CENTRE FOR OBESITY, DIABETES AND CARDIOVASCULAR DISEASE

SYDNEY UNIVERSITY
MODIFICATION 2

Section 75W Environmental Assessment Report
November 2011

FIGURE 3 – BUILDING MASS DIAGRAM

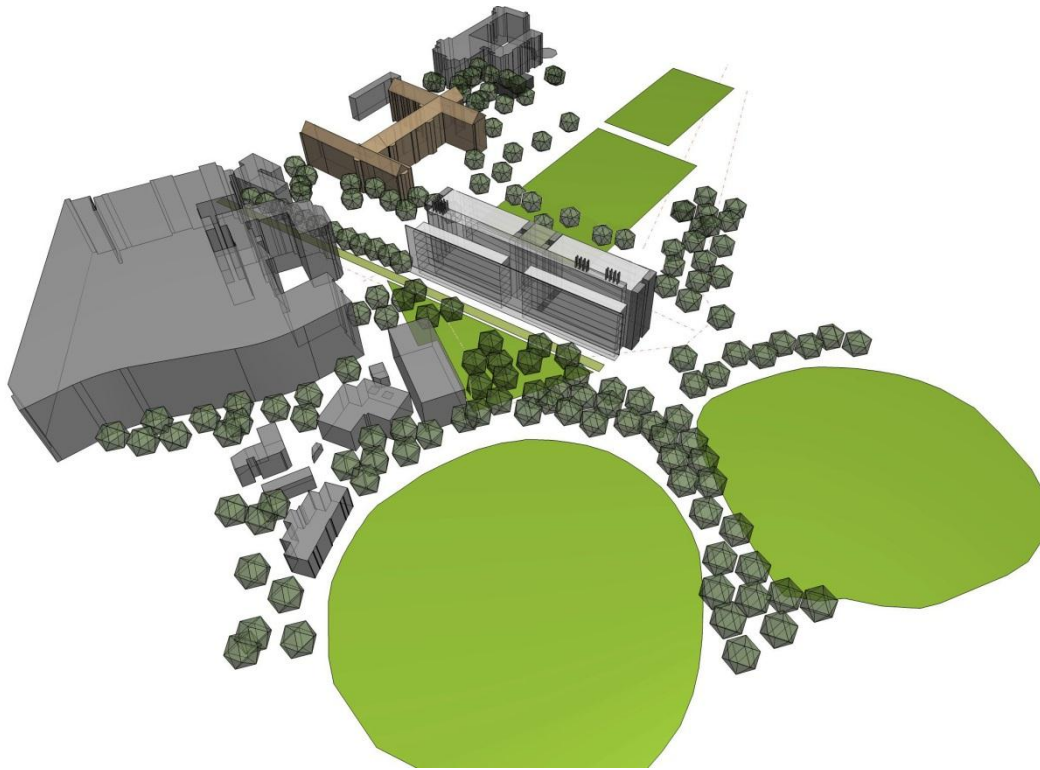
- The reconfigured floor plate has translated the building mass to a more linear and streamlined building of two parallel wings connected by a central atrium. This reconfiguration results in a more compact built form that reflects the linear building composition of St Johns College (Refer to Figure 3 below).

- The proposed linear building configuration creates the opportunity to create an open space area between the building and the Centenary Institute. This provides greater spatial separation between these buildings and establishes a more significant and celebrated public space. In conjunction with the two adjacent ovals, this open space area will also enhance the junction of John Hopkins Drive and Regimental Drive (Refer to Figure 3 below).

FIGURE 4 – VIEW CORRIDOR ALONG JOHN HOPKINS DRIVE

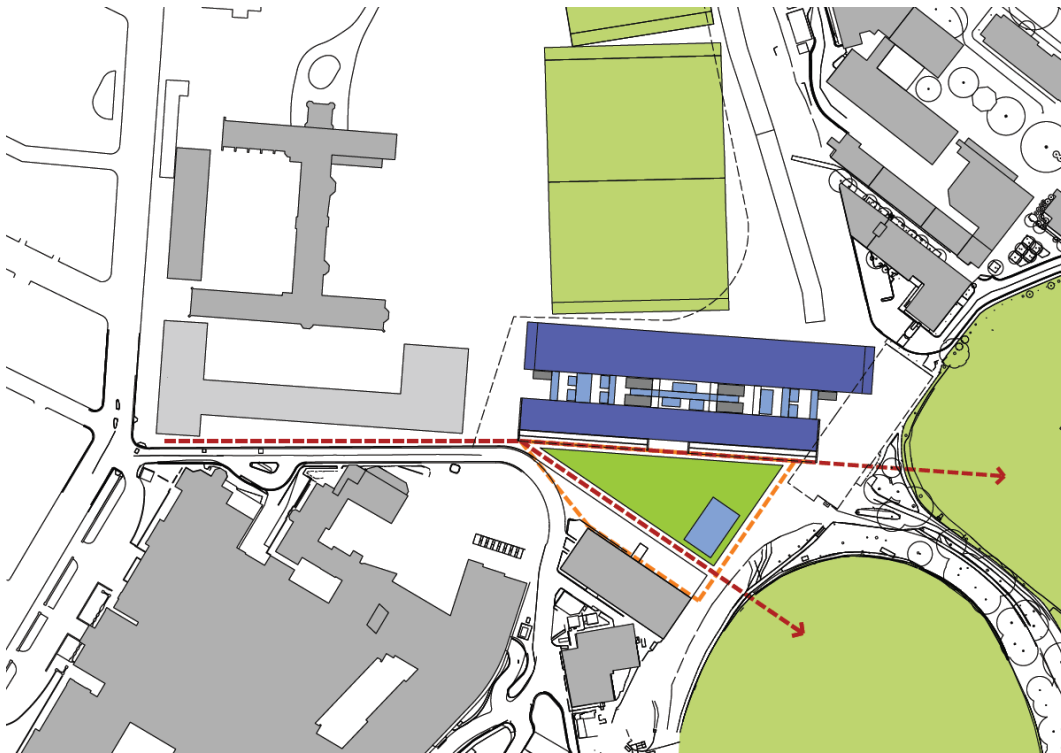
- There will be an improvement to the extent of view from the St Johns College to the east due to the removal of the previous eastern wing and the widening of the gap between the CODCD building and the Centenary Institute building.
- Relative to the views as seen from Parramatta Road, the building will present as a more elongated built form but will maintain views to St Johns College.
- The view corridor from Missenden Road along John Hopkins Drive will be towards the proposed open space plaza due to the siting of the building adjacent to John Hopkins Drive (refer to Figure 4 below).
